U.S. Department of Energy
Office of River Protection

04-WTP-268

U.S. DEPARTMENT OF ENERGY (DOE), OFFICE OF RIVER PROTECTION (ORP)
RESPONSES TO THE DEFENSE NUCLEAR FACILITIES SAFETY BOARD (DNFSB)
CONCERNS

Responses to Issues Raised in July 21, 2004 Defense Nuclear Facilities Safety Board (DNFSB) Letter Regarding Waste Treatment and Immobilization Plant (WTP) Ventilation Systems Design

Calc No.: 24590-PTF-S0C-S15T-00005, Rev. 0A

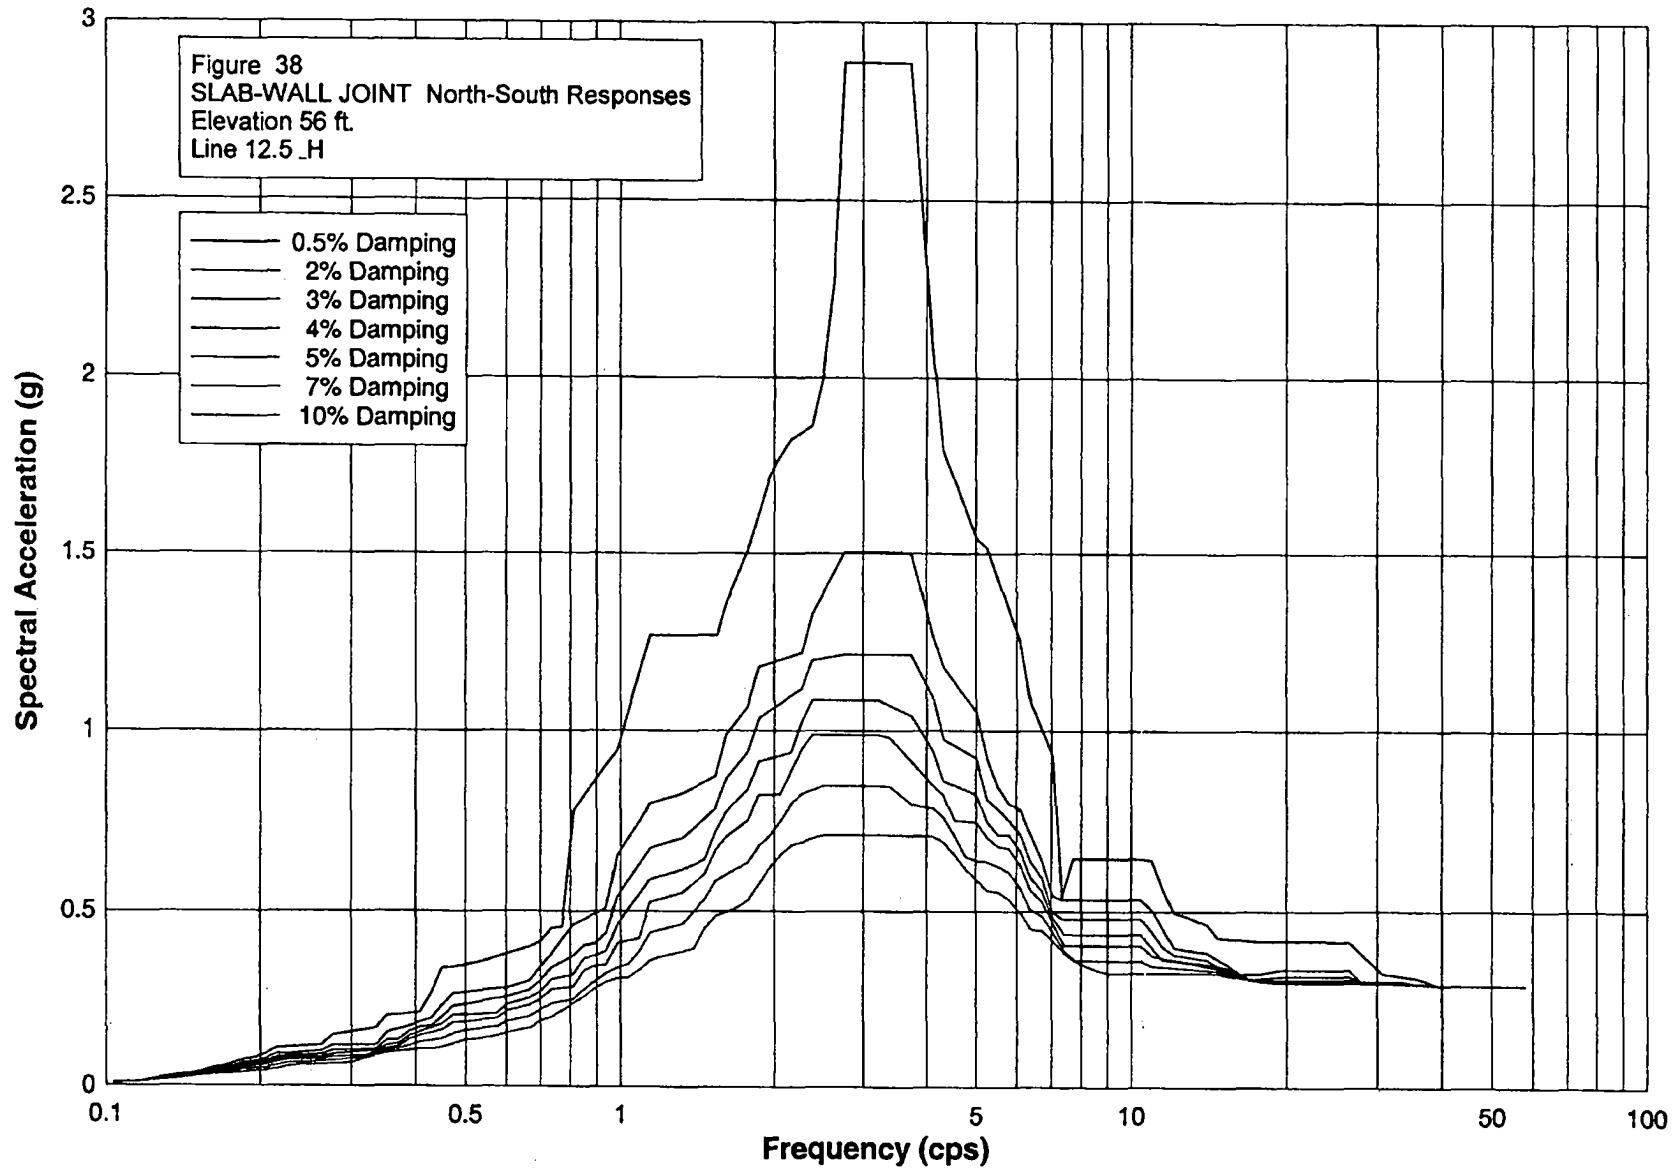
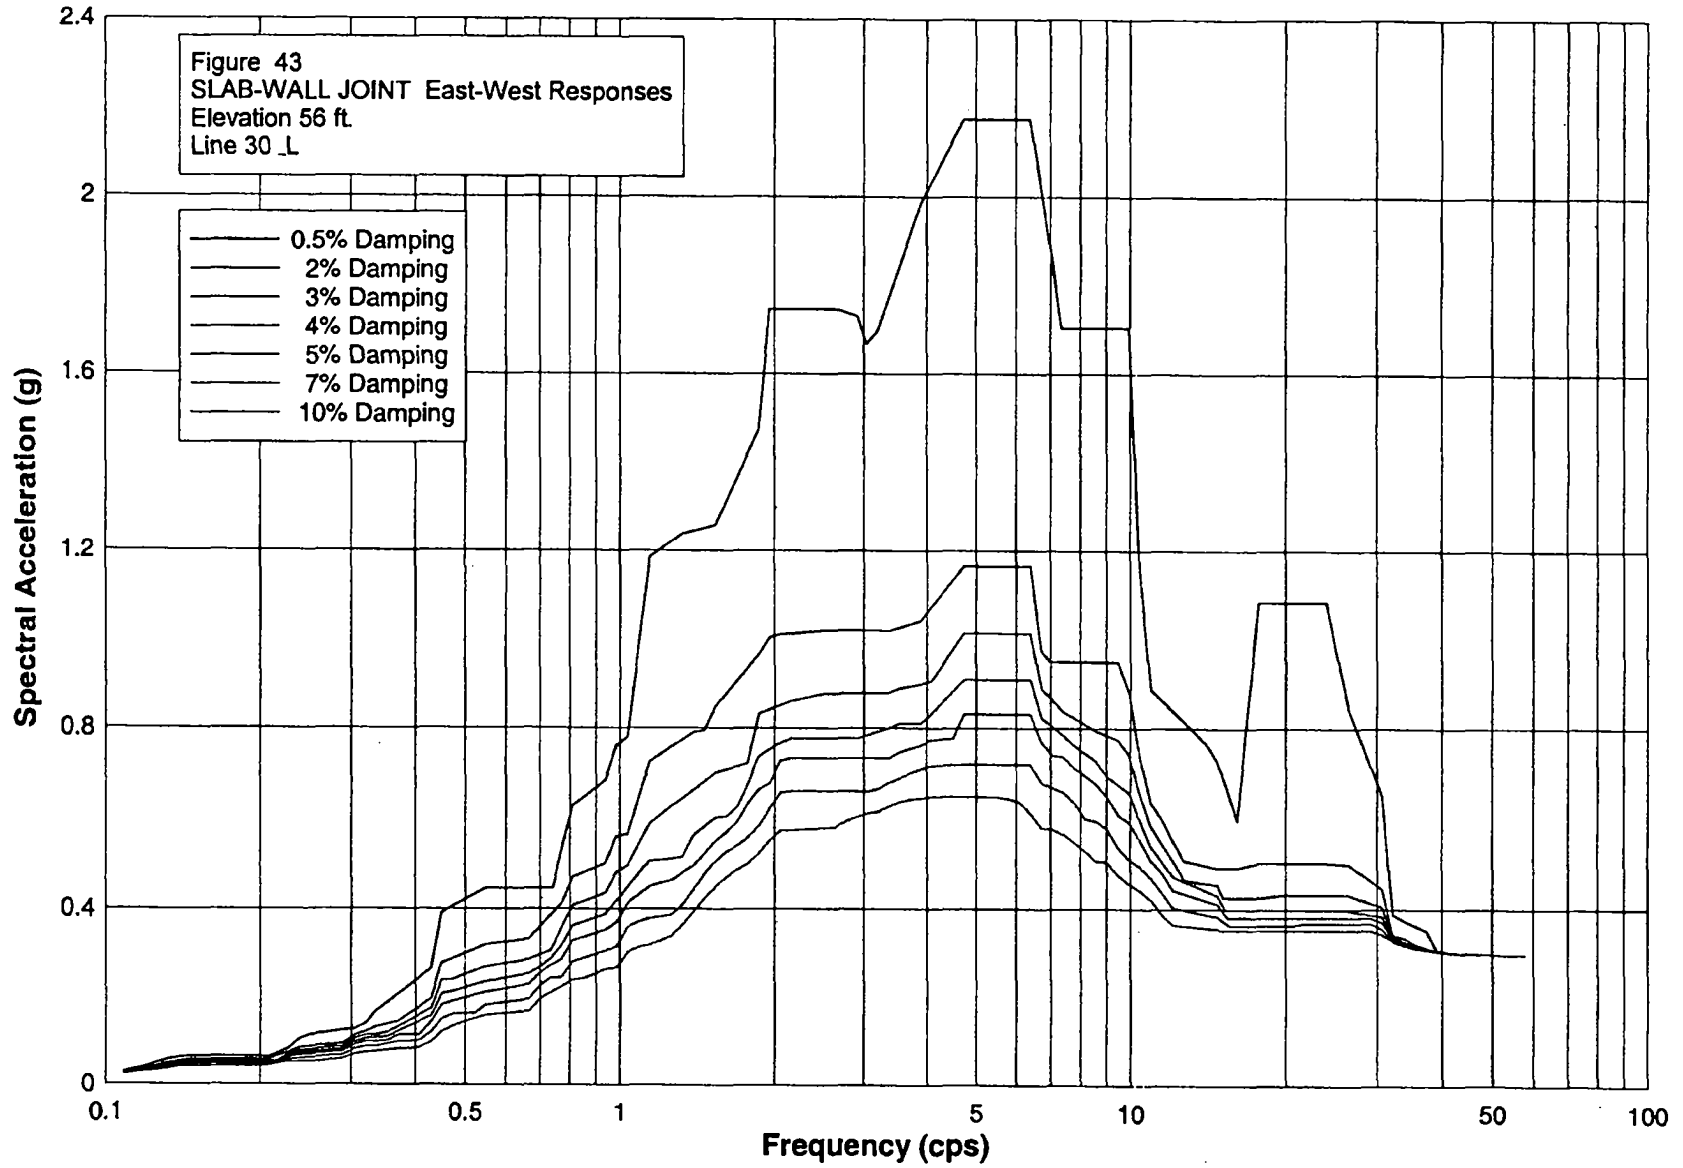
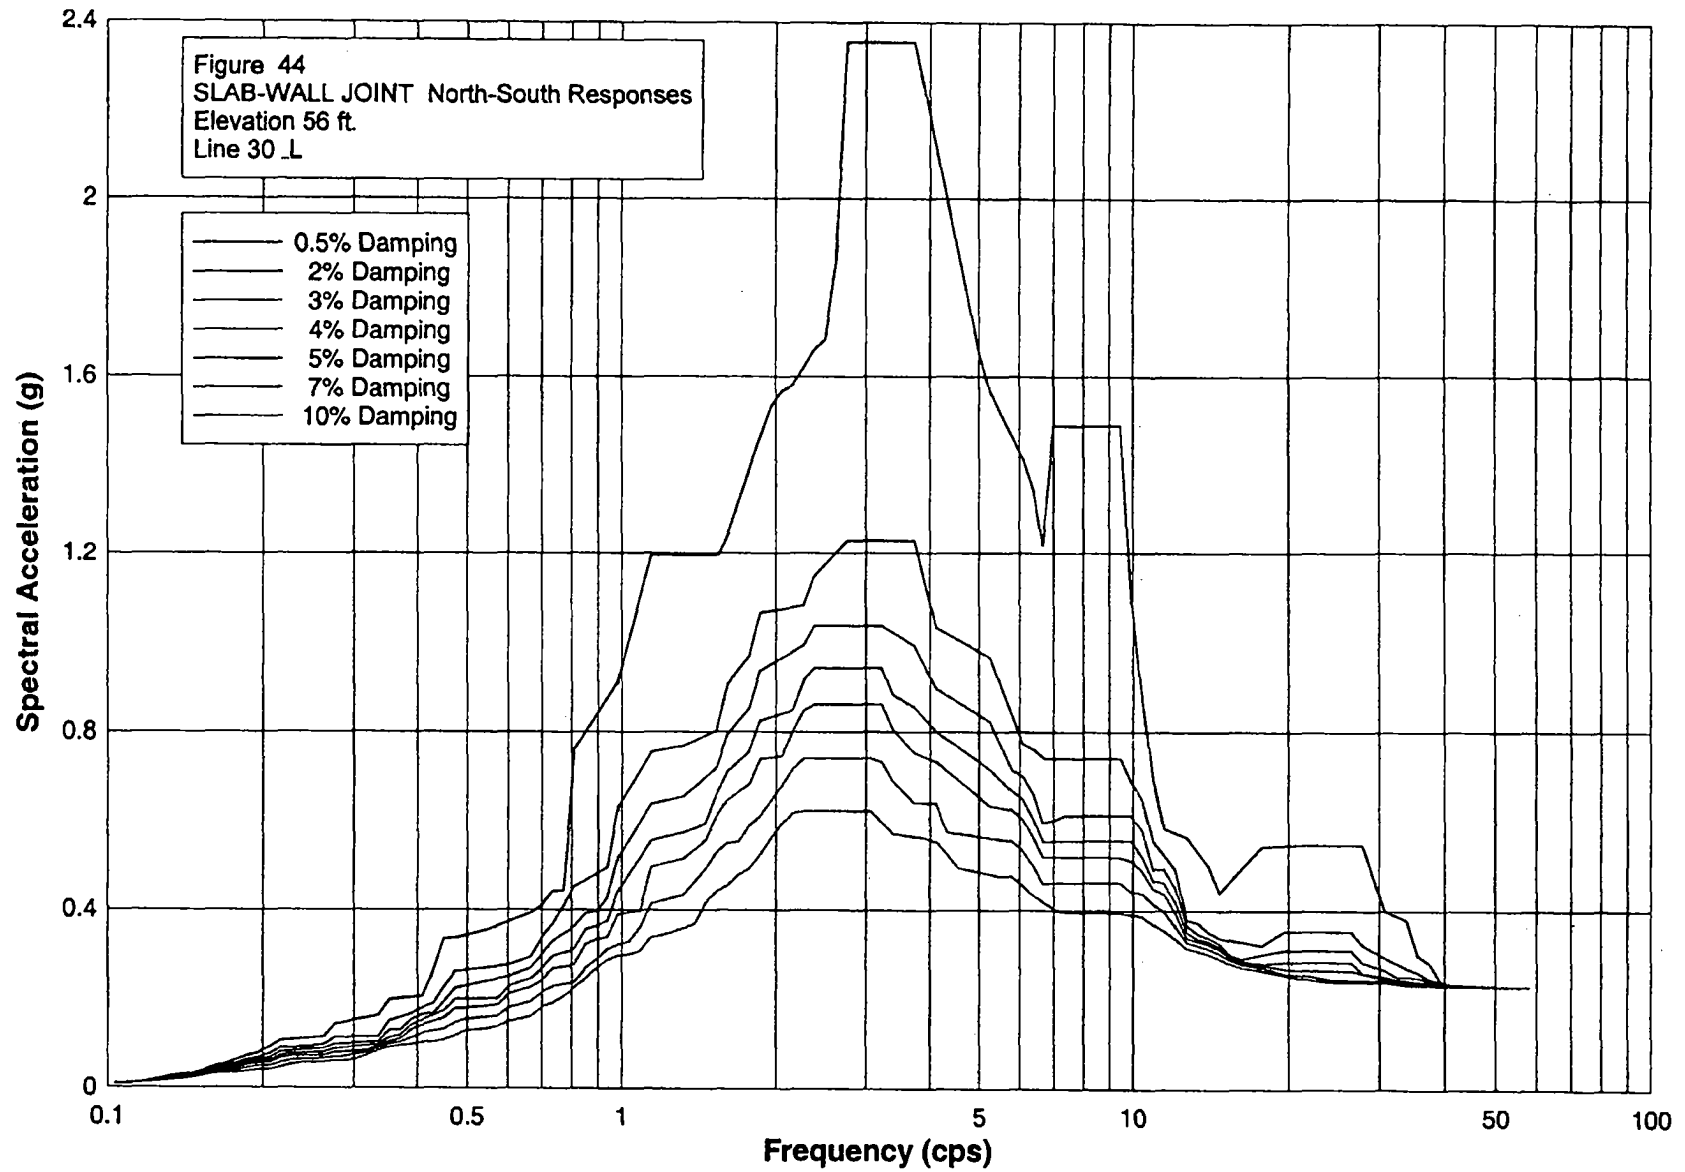
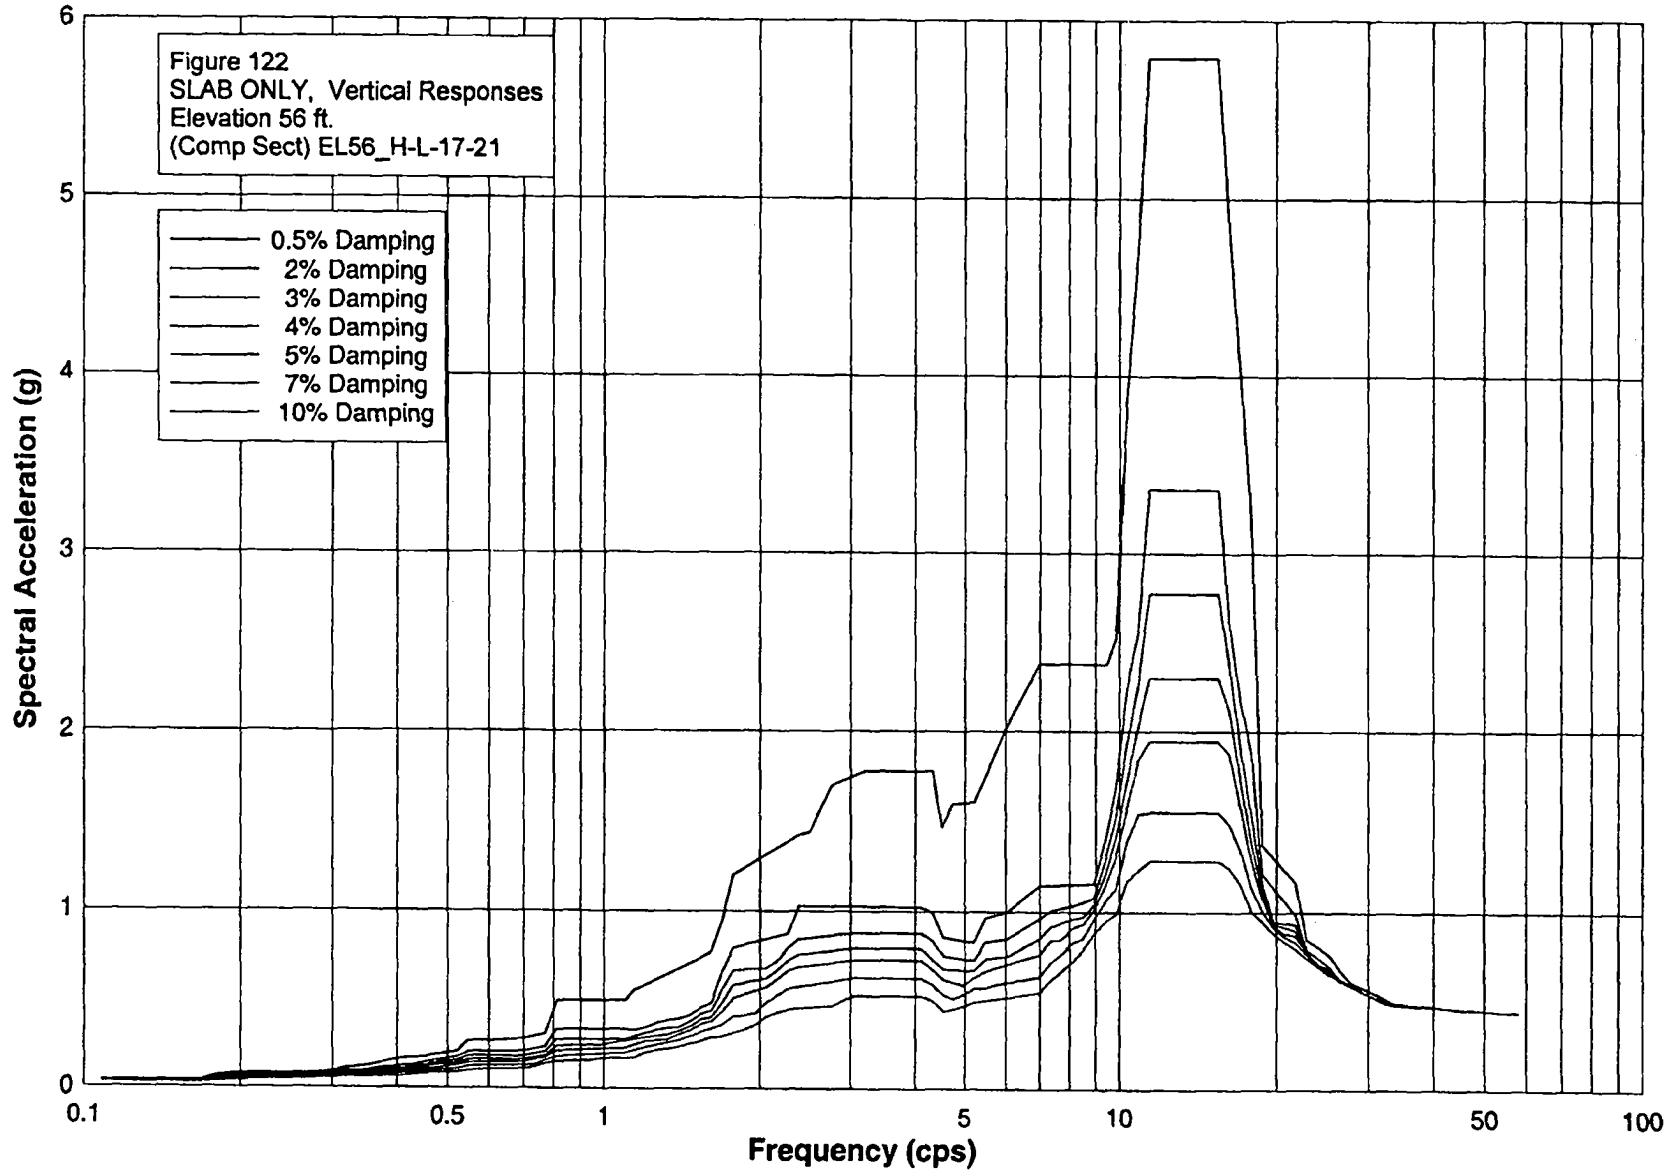
WTP-04-281-02 The planned ventilation filter housing shaker table tests will use a bounding seismic spectra as input for the shaker table tests. The staff wants to review the bounding data for suitability.

Response: The WTP Project will not use bounding data for the PT and HLW facilities. The specific In-Structure Response Spectra (ISRS) curves for each facility will be used and separate testing for each facility will be conducted. The applicable curves, by elevation and column line, for the Remote Change HEPA Filter housings will be used which shows the expected frequencies and accelerations in the north/south, east/west, and vertical directions. The reason for applying the ISRS curves specific to each building and not using bounding data is as follows:

Enclosed are the ISRS curves applicable to the Remote Change HEPA Filter housings in the HLW and PTF facilities.+
